| PROJECT REFERENCE NO. U-2579B | SHEET NO. 26 |

DOCUMENT NOT CONSIDERED FINAL
 UNLESS ALL SIGNATURES COMPLETED
**PERMIT DRAWING
 MODIFICATION FOR
 SITE 23 AND 28**

NC DEPARTMENT OF TRANSPORTATION
 DIVISION OF HIGHWAYS
 6-2-14
 U-2579B FORSYTH COUNTY
 WINSTON SALEM NORTHERN BELTWAY
 (EASTERN SECTION) (FUTURE I-74)
 SHEET 62 OF 64

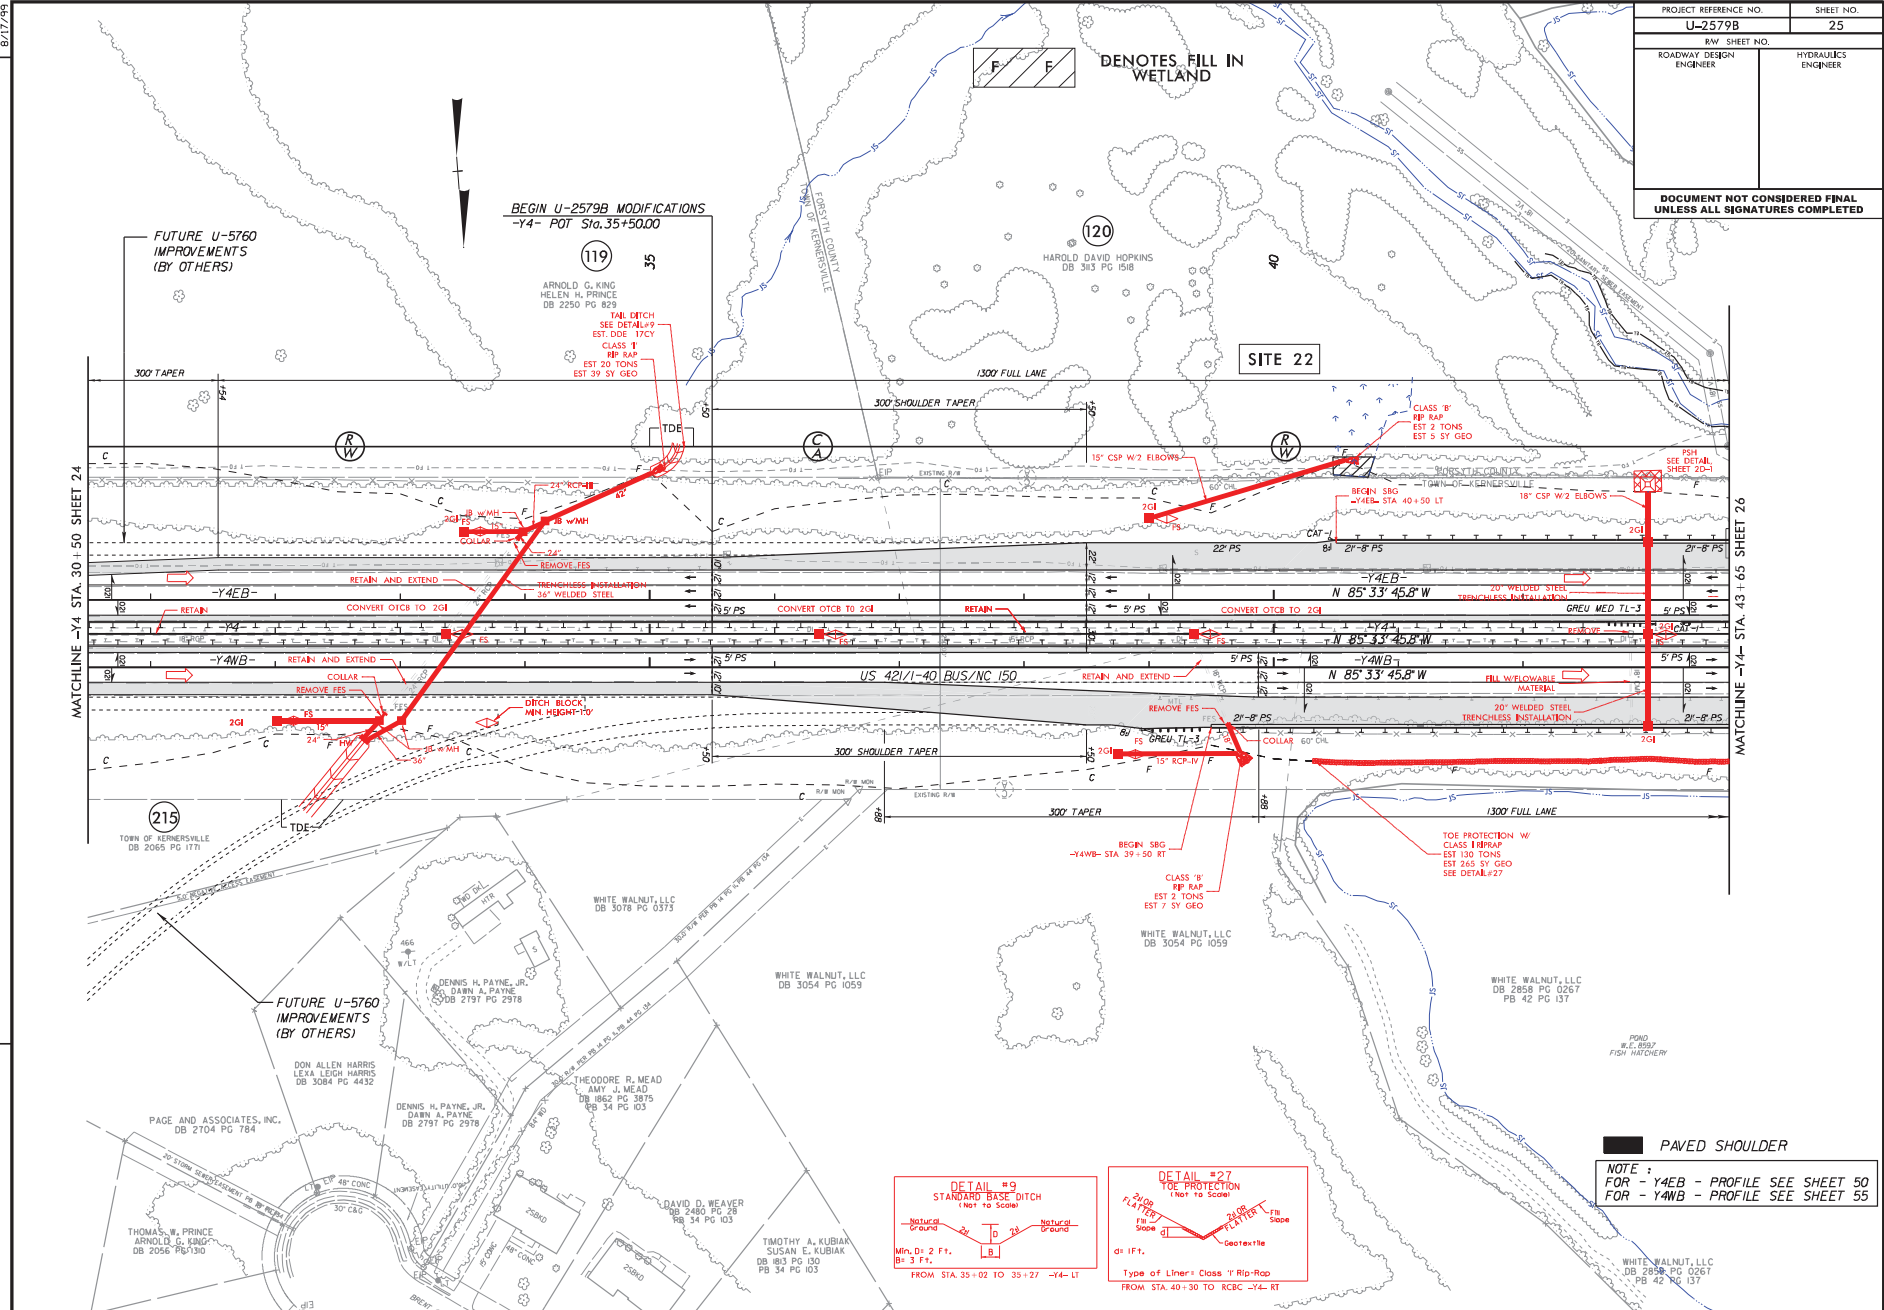
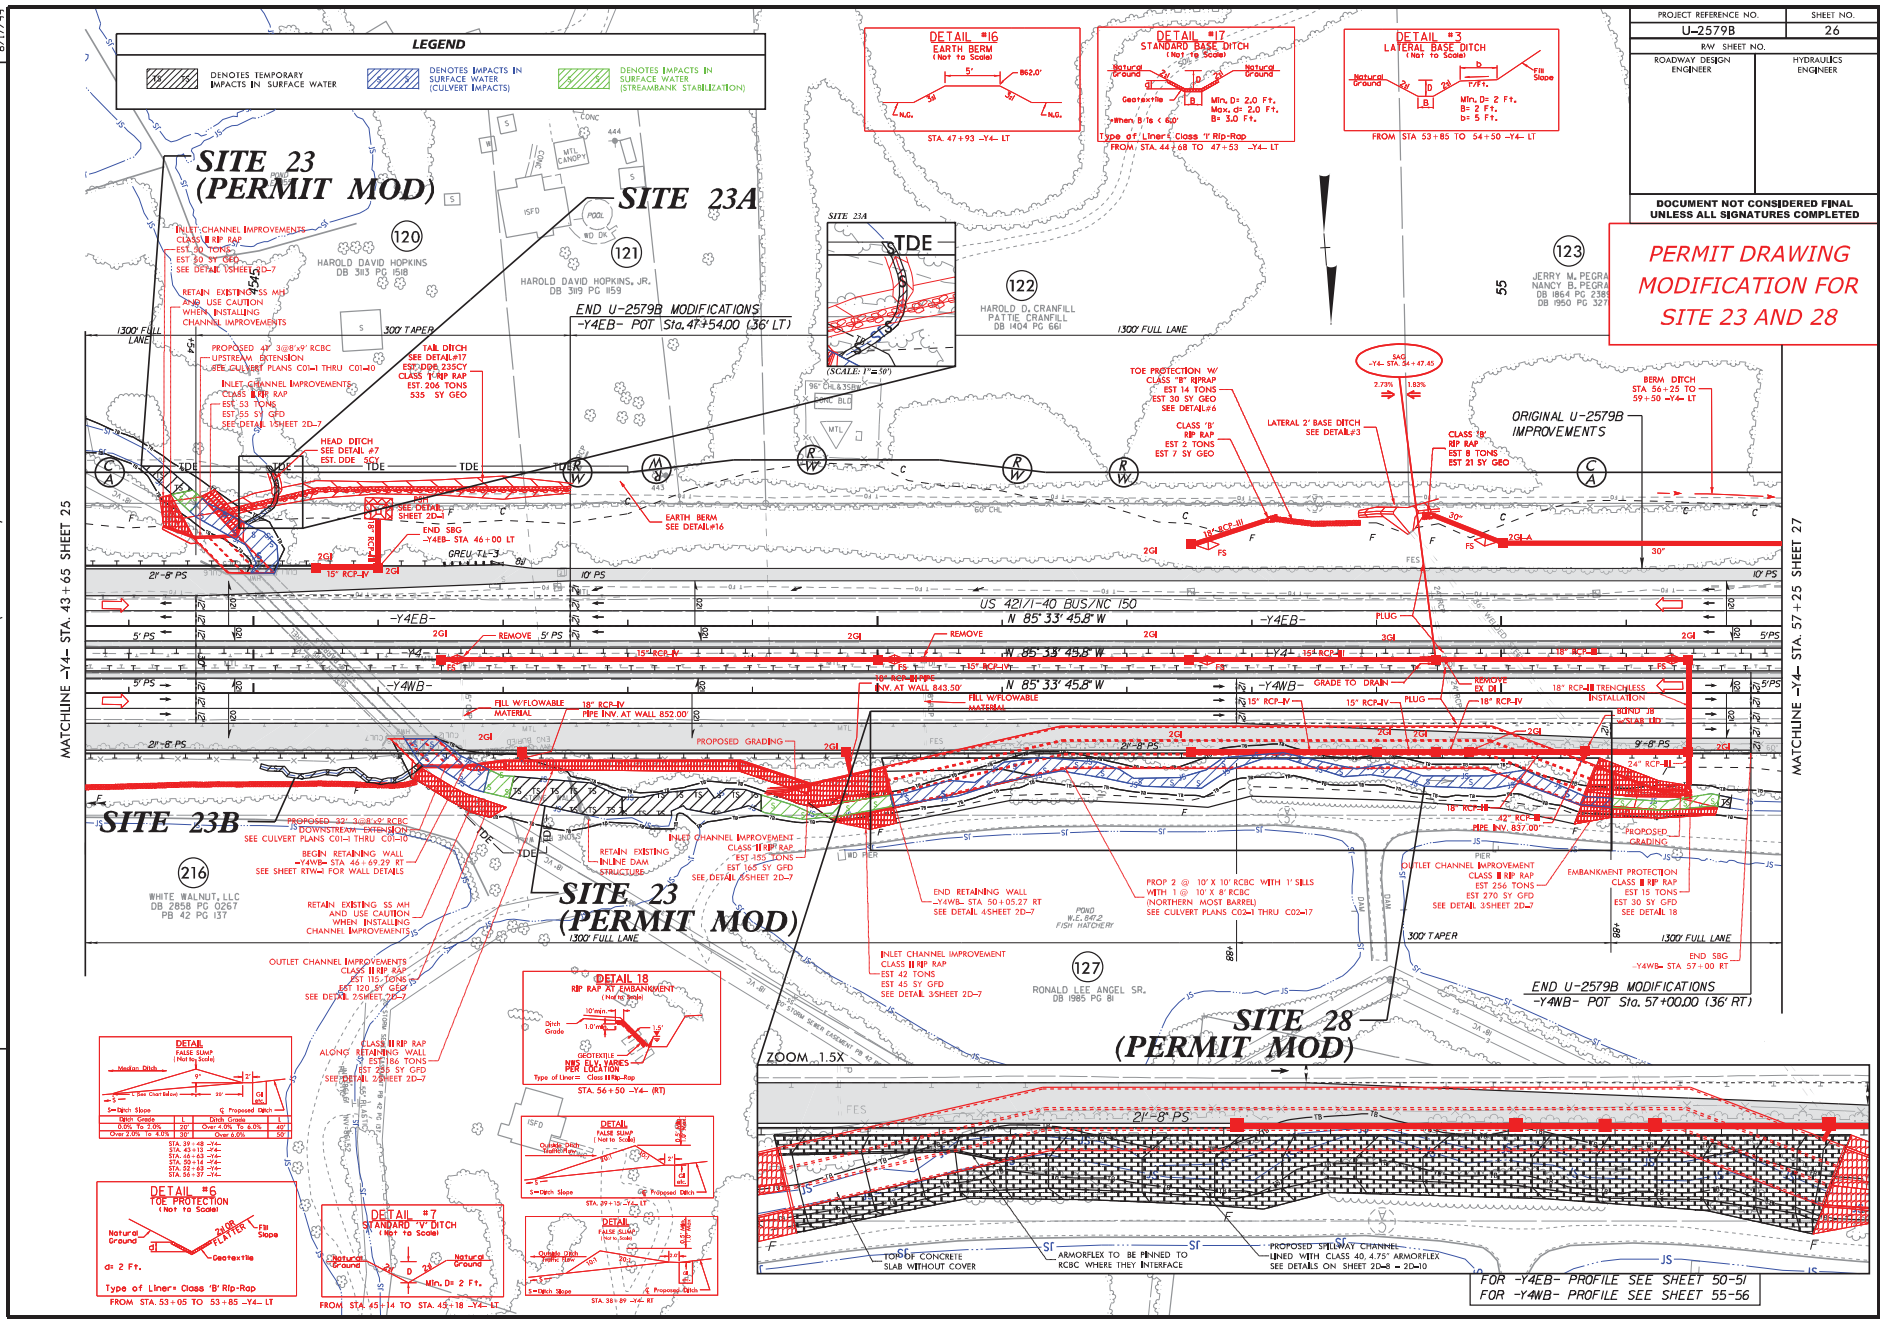
REVISIONS
 CONSTRUCTION REVISION - 11/16/18 - REVISED ROADWAY AND HYDRAULIC DESIGN TO ACCOUNT FOR FUTURE U-5760 PROJECT, BEGINNING AT -Y4- STA. 35+50.00 - RSH

CONSTRUCTION REVISION - 11/16/18 - REVISED ROADWAY AND HYDRAULIC DESIGN TO ACCOUNT FOR FUTURE U-5760 PROJECT, INCLUDING RETAINING WALL AND CULVERT ON NORTH SIDE OF -Y4- MATCHLINE MOVED TO -Y4- STA 57+25 (FROM 56+61) TO ILLUSTRATE ALL CHANGES ON PLAN SHEET 26, -RSH
 REVISIONS
 MATCHLINE -Y4- STA. 43+65 SHEET 25
 MATCHLINE -Y4- STA. 57+25 SHEET 27

SITE 23 (PERMIT MOD)
 INLET CHANNEL IMPROVEMENTS CLASS II R/R RAP EST 30 TONS SEE DETAIL #16-7
 RETAIN EXISTING MSH AND USE CAUTION WHEN INSTALLING CHANNEL IMPROVEMENTS
 PROPOSED 47' 3/8" x 8" RCBC USTREAN EXTENSION SEE CULVERT PLANS C041 THRU C040
 INLET CHANNEL IMPROVEMENTS CLASS II R/R RAP EST 53 TONS SEE DETAIL #16-7
 HEAD DITCH SEE DETAIL #7 EST. DDE
 14" DITCH SEE DETAIL #17 CLASS II R/R RAP EST. 206 TONS 535' SY GEO
 END U-2579B MODIFICATIONS -Y4EB- POT Sta. 47+54.00 (36' LT)

SITE 23B
 PROPOSED 32' 3/8" x 8" RCBC DOWNSTREAM-EMBANKMENT SEE CULVERT PLANS C041 THRU C040
 BEGIN RETAINING WALL -Y4WB- STA 46+69.29 FT SEE SHEET RYW-4 FOR WALL DETAILS
 RETAIN EXISTING MSH AND USE CAUTION WHEN INSTALLING CHANNEL IMPROVEMENTS
 OUTLET CHANNEL IMPROVEMENTS CLASS II R/R RAP EST 120 SY GEO SEE DETAIL #18 SHEET 26-7
SITE 23 (PERMIT MOD)
 1300 FULL LANE
 END U-2579B MODIFICATIONS -Y4WB- POT Sta. 57+00.00 (36' RT)

SITE 28 (PERMIT MOD)
 ZOOM 1.5X
 PROPOSED 21' x 8' PS
 TOP OF CONCRETE SLAB WITHOUT COVER
 ARMORLEX TO BE PINNED TO RCBC WHERE THEY INTERFACE
 PROPOSED STEELWAY CHANNEL LINED WITH CLASS 40.475' ARMORLEX SEE DETAILS ON SHEET 20A - 20A-D
 END 58G -Y4WB- STA 57+00 FT

| U-2579B | 26 |

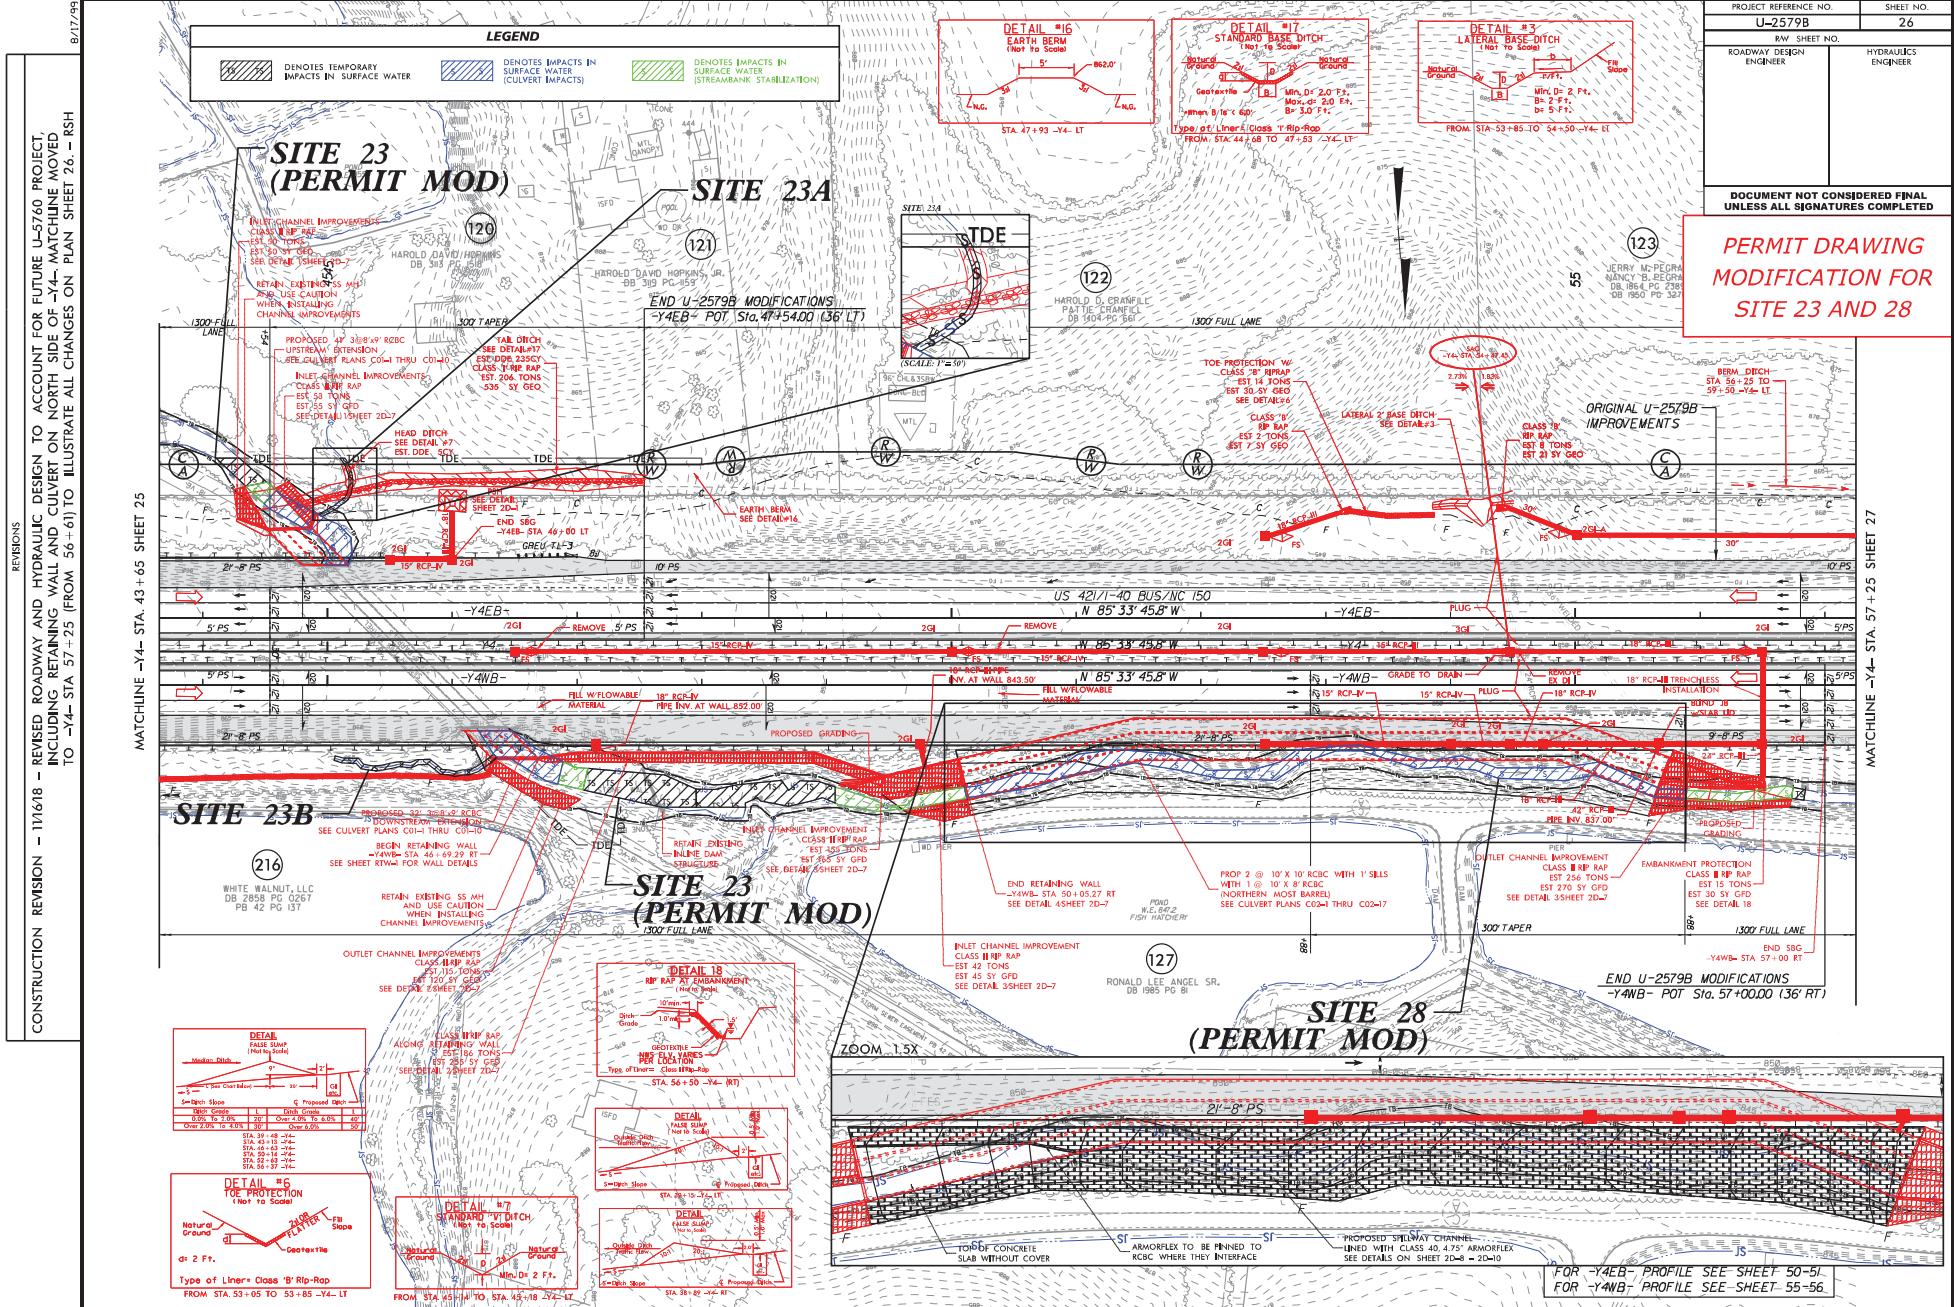
REVISIONS
 CONSTRUCTION REVISION - 11/16/18 - REVISED ROADWAY AND HYDRAULIC DESIGN TO ACCOUNT FOR FUTURE U-5760 PROJECT, INCLUDING RETAINING WALL AND CULVERT ON NORTH SIDE OF -Y4- MATCHLINE MOVED TO -Y4- STA 57+25 (FROM 56+61) TO ILLUSTRATE ALL CHANGES ON PLAN SHEET 26 - RSH
 B/17/19
